Bulletin No.: PI1341A Date: 10-Jun-2016

Subject: Cooled Seat Fan Making Tapping Noise When in Use

Models: 2014-2017 Chevrolet Impala (VIN 1)

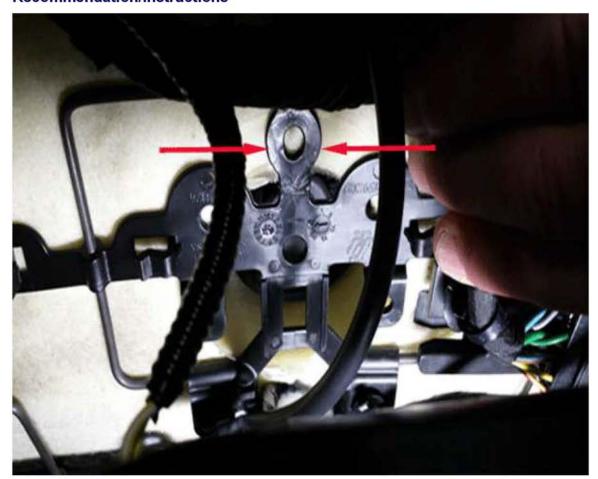
Some customers may comment on a tapping noise heard when using cooled seats.

This condition may be due to the seat cushion heat harness coming in contact with the cooling fan.

Re-route the seat cushion heat harness under the flex mat away from the cooling fan and attach a harness clip to the new location under the seat as shown above.
